NEW UG CHILLED WATER LINES – WEST SIDE USU
OSE# R0324-12X/DEL
SDSU# 25-15440
South Dakota State University
Brookings, South Dakota
2025

ADDENDUM NO. 1
March 17, 2025

SHEET NO.
U002

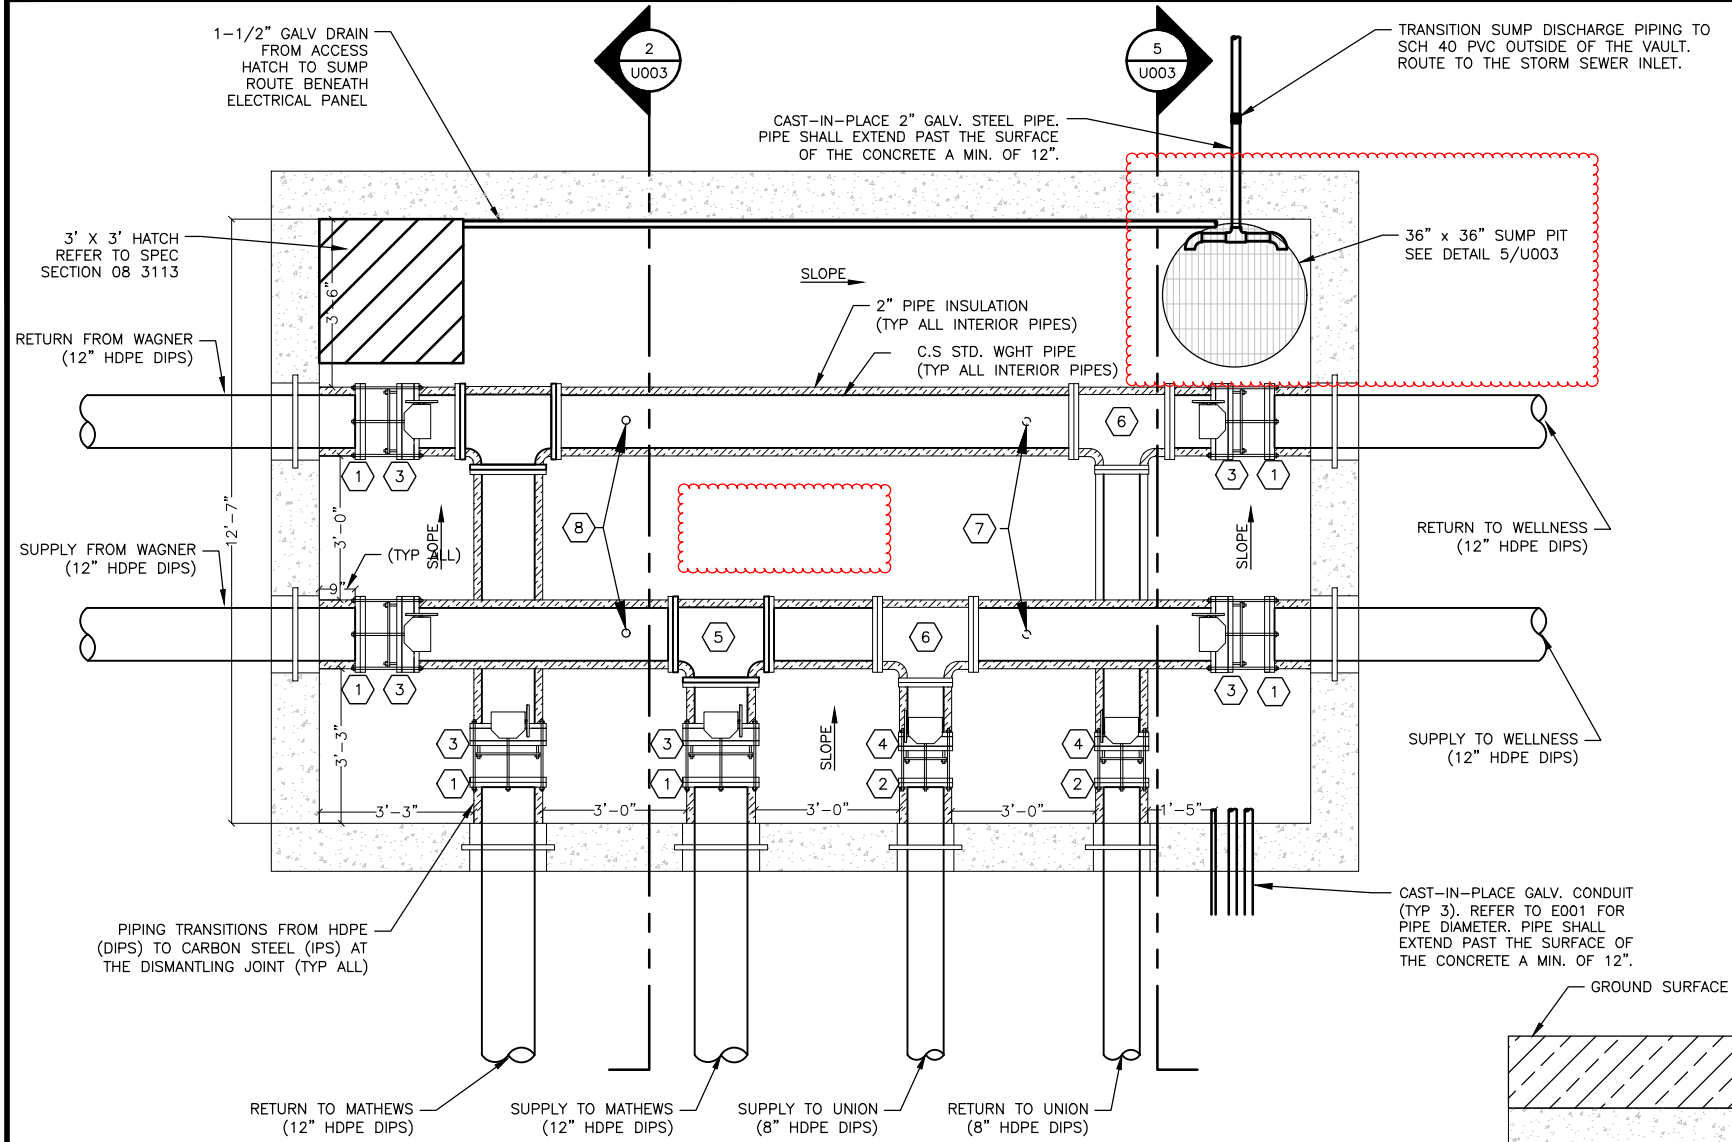
11. Sheet U002 – SPECIAL DETAILS:

Replace sheet in its entirety with attached.

Removed unintentional lines from Detail 5.

SHEET NO.
U003

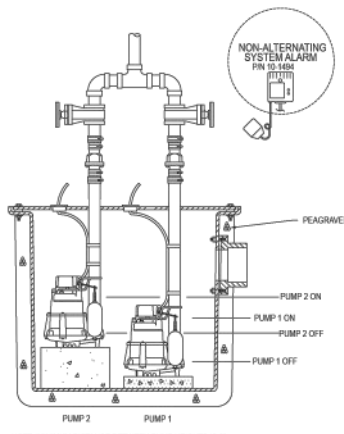
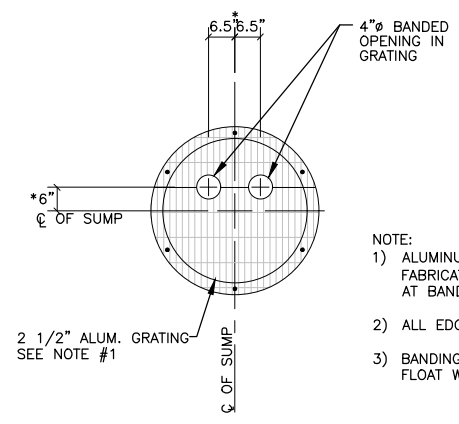
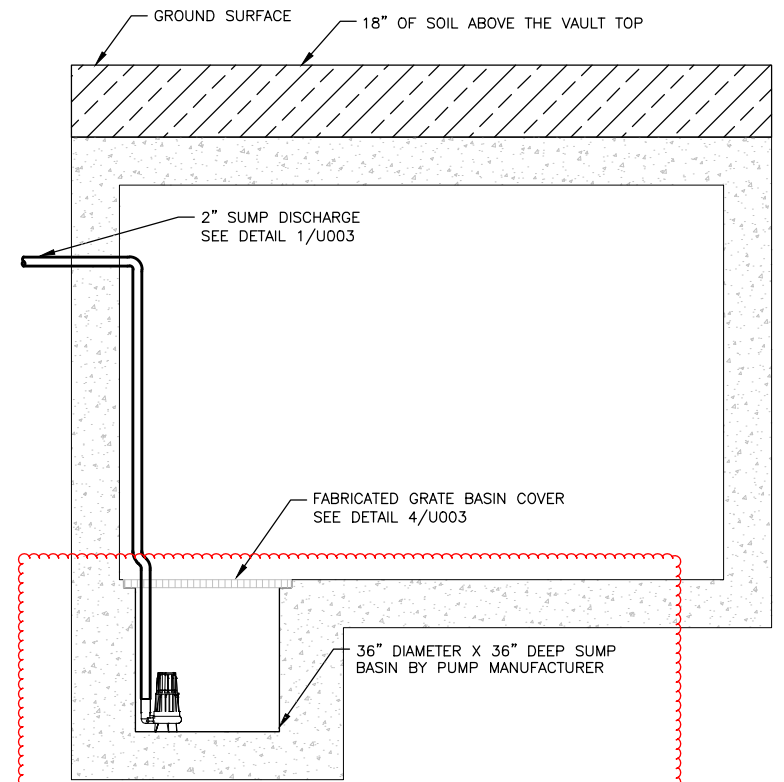
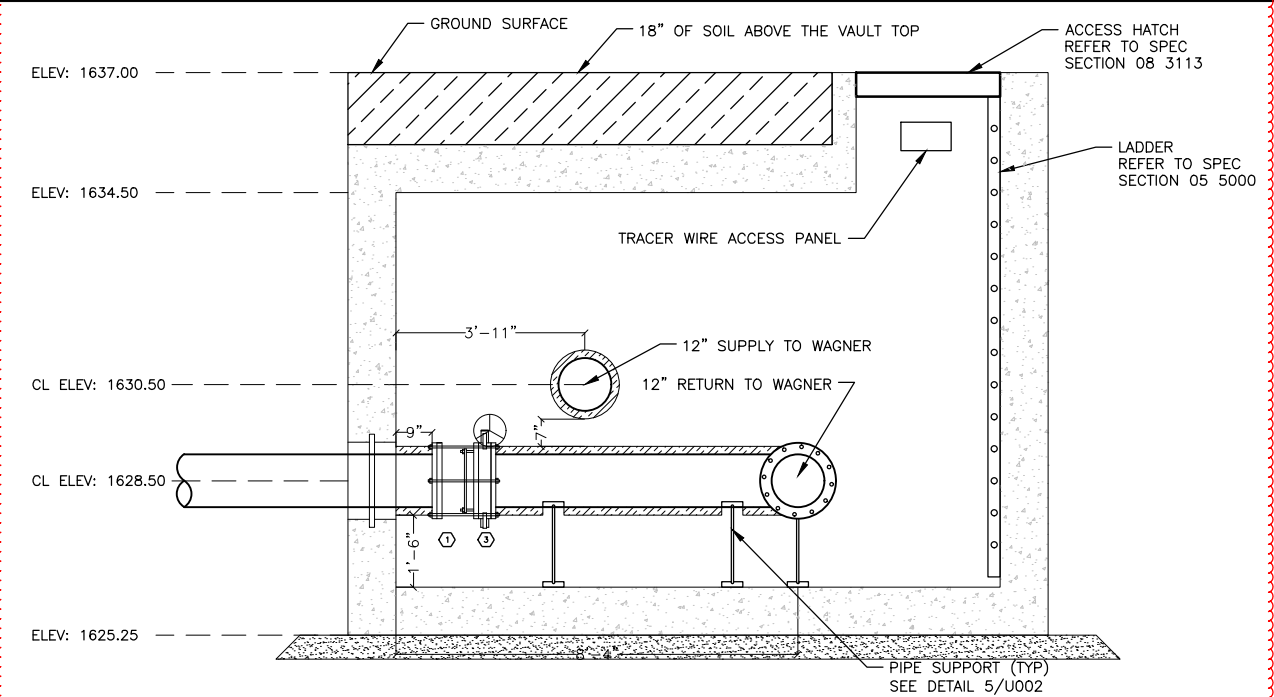
12. Sheet U003 – SPECIAL DETAILS:

Replace sheet in its entirety with attached.

Removed rebar shown on S sheets.

Added concrete foundation around sump for clarification.
